Topic: Draft 1 Version 3.1 ENERGY STAR® Specification for Pool Pumps (Connected Criteria)

This letter comprises the comments of the Pacific Gas and Electric Company (PG&E), San Diego Gas and Electric (SDG&E), and Southern California Edison (SCE) in response to the United States (U.S.) Environmental Protection Agency (EPA) Draft of the Version 3.1 ENERGY STAR Specification for Pool Pumps (Connected Criteria).

Figure 1: Daily UV index for Los Angeles CA, 2017

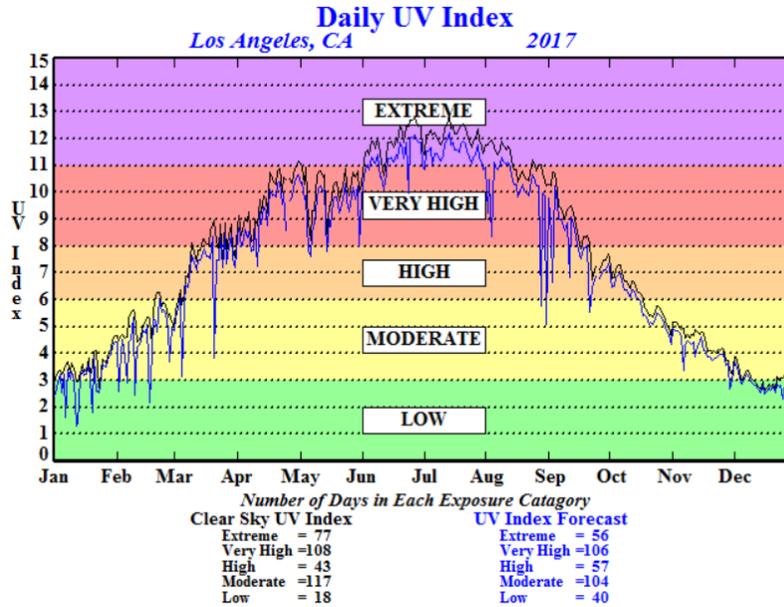
Automatic chlorine systems have the benefit of lower peak chlorine levels, but conversely must be calibrated to maintain recommended levels. The ultraviolet (UV) sunlight degradation of chlorine sanitizers is a well-known issue, where un-stabilized chlorine is noted to be reduced by 90 percent in two hours;¹⁷ to combat this, pool chlorine is typically stabilized with cyanuric acid (CYA), either directly or via Dichlor or Trichlor products. In our literature review, we discovered experimental data documenting that free chlorine loss in pool water stabilized at preferred CYA levels,^{18, 19} 55 and 35 ppm, exposed to a typical “High” UV index day²⁰ would lose up to 60 and 75 percent of free chlorine levels per day, respectively (as seen in Figure 1).

Figure 2: Daily free chlorine loss in PPM by CYA concentration, at UV index of 7.4.

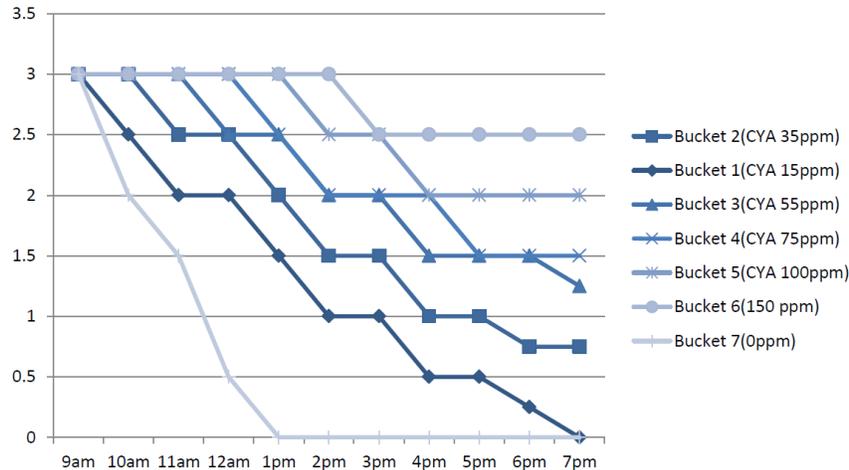
In Figure 2, A. Askins uses five gallon buckets for this experiment. Bucket 6 (CYA 150 ppm), which is an extreme best-case scenario for chlorine loss, is corroborated with a field test with a 25,000 gallon pool at 138 ppm CYA in Phoenix, Arizona: this source daily free chlorine loss rate is 15 percent,²² Askins' loss rate: approximately 17 percent (Bucket 6). Note modern pool guidelines recommend draining a pool if CYA concentration exceeds 100 ppm,²³ for consumer health and loss of chlorine oxidation effectiveness concerns.

As chlorine in this system requires daily replenishment at an accurate rate, we caution the use of DR events below the minimum flow rate of the chlorine generator, which lowers production and ultimately lowers free chlorine levels below targets. For example, the footnoted salt chlorine generator requires a minimum flow rate of 25 gallons per minute (gpm).²⁵ In this scenario, the minimum flow setpoint may have to be set to above the DR default value to protect the consumer experience.
